6/24/14	Added New Sheet.
DATE	REVISION
STATE OF HAWAII DEPARTMENT OF TRANSPORTATION HIGHWAYS DIVISION	
WATER POLLUTION & EROSION CONTROL NOTES	
HALEAKALA HIGHWAY INTERSECTION IMPROVEMENTS AT KULA HIGHWAY Project No. 37C-01-14	
Date: June, 2014	
SHEET No. 1 OF 3 SHEETS

6/24/14	Added Notes.
DATE	REVISION
STATE OF HAWAII DEPARTMENT OF TRANSPORTATION HIGHWAYS DIVISION	
TYPICAL SECTIONS & DETAILS	
HALEAKALA HIGHWAY INTERSECTION	
IMPROVEMENTS AT KULA HIGHWAY	
Project No. 37C-01-14	
Scale: As Shown	Date: April, 2014
SHEET No. 1 OF 3 SHEETS

DEMOLITION PLAN

**HALEAKALA HIGHWAY INTERSECTION
IMPROVEMENTS AT KULA HIGHWAY**

DEMOLITION PLAN

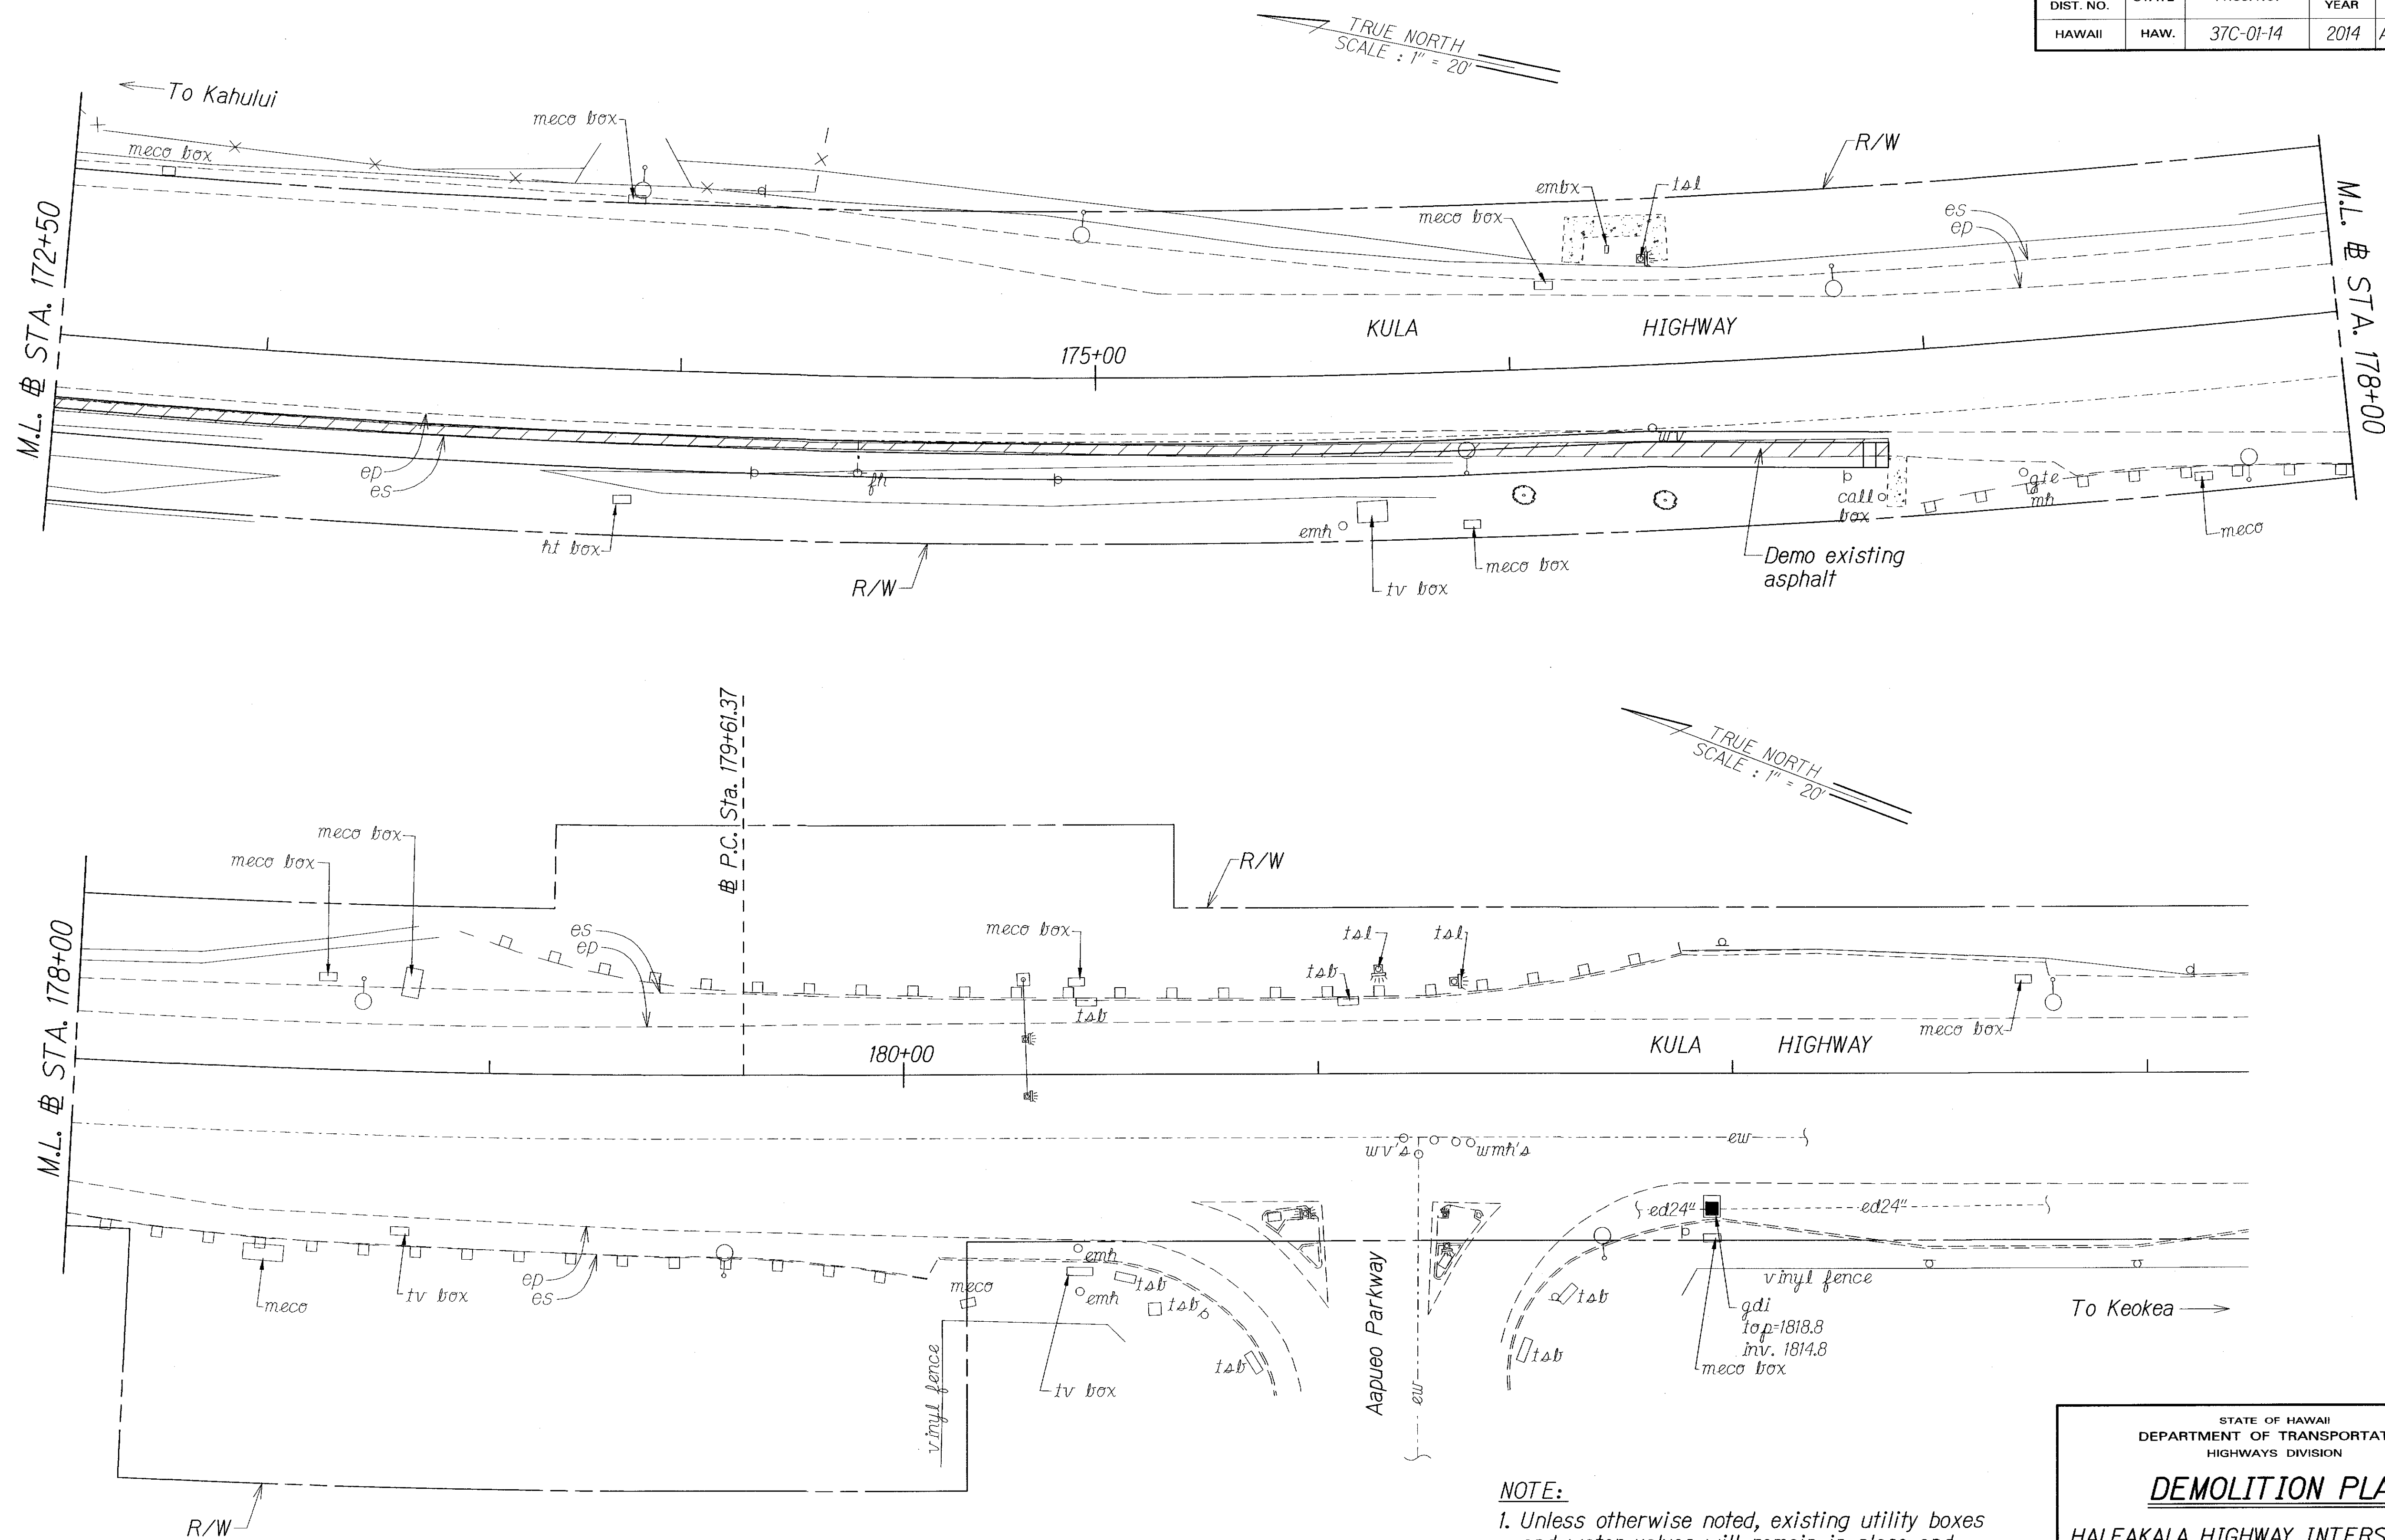
6-25-14 Revised notes.

- NOTE:**
1. Unless otherwise noted, existing utility boxes and water valves will remain in place and adjusted to new finish grade.
 2. Remove all markings and markers that conflict with the new markings and markers shown on the Signing and Pavement Marking Plans.

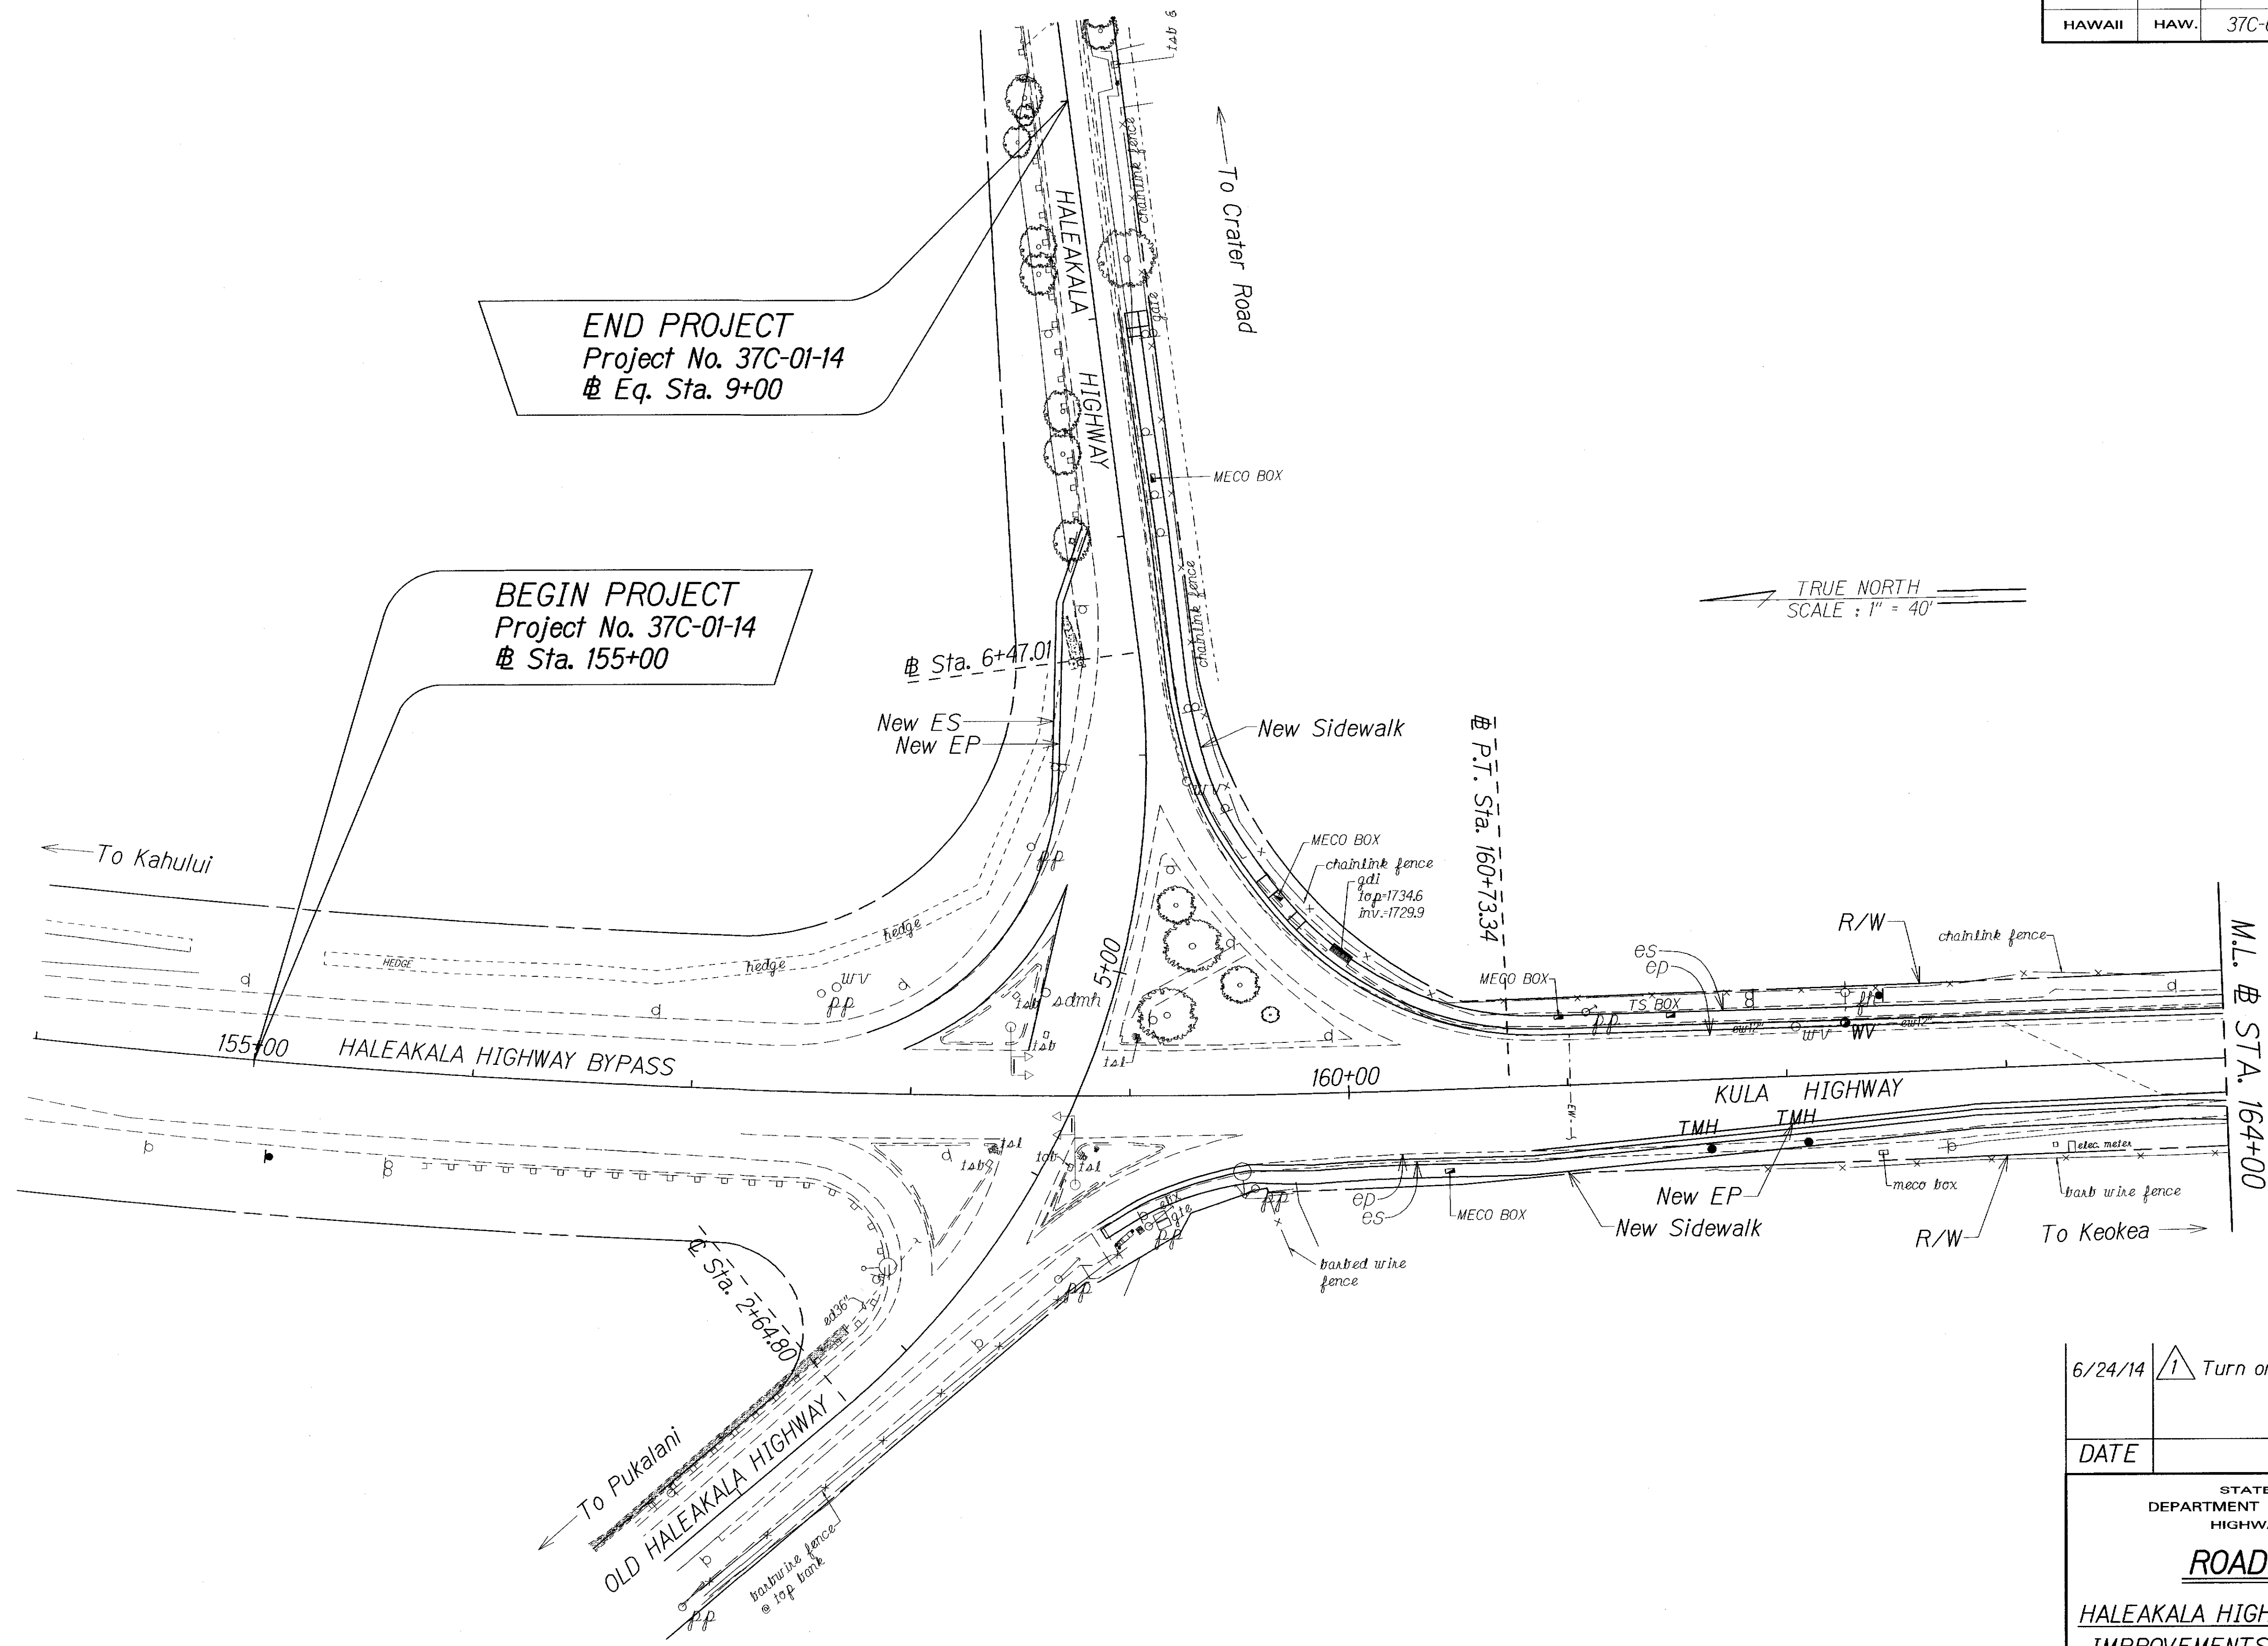
Turn on Correct Levels.

ROADWAY PLAN

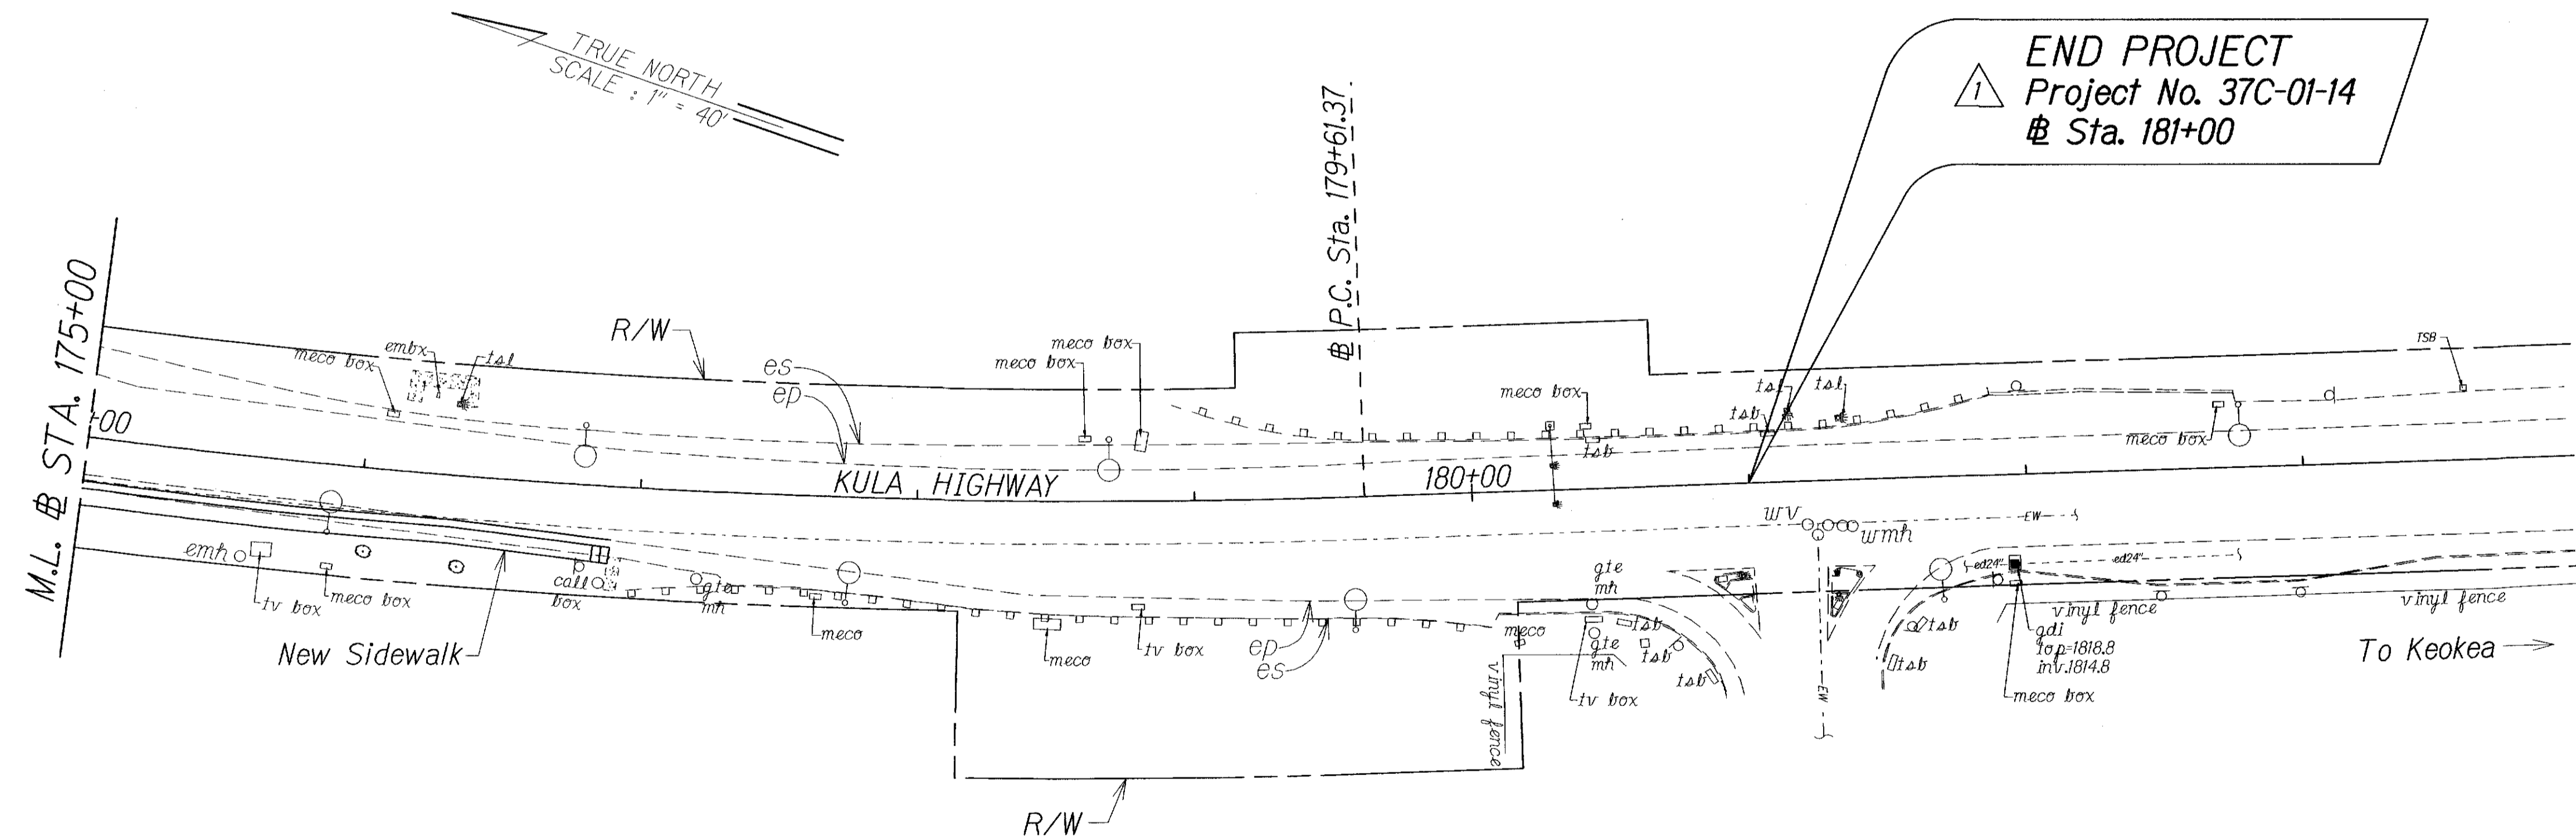
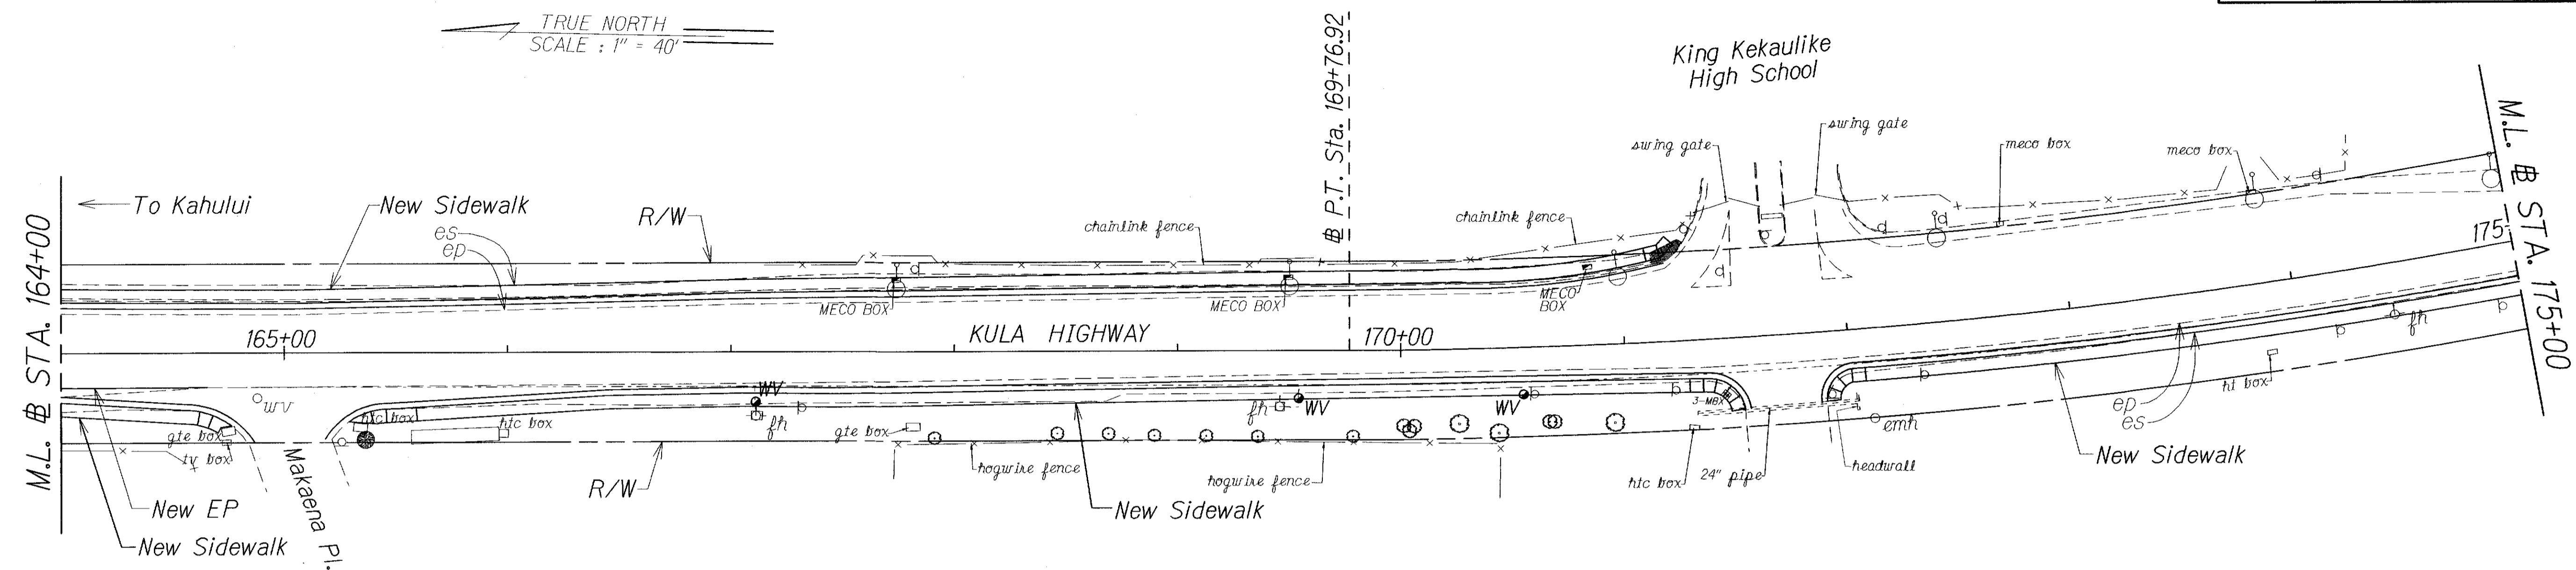
6/24/14	<div>1</div> <div>Turn on Correct Levels and Corrected Kula Highway End of Project.</div>
DATE	REVISION
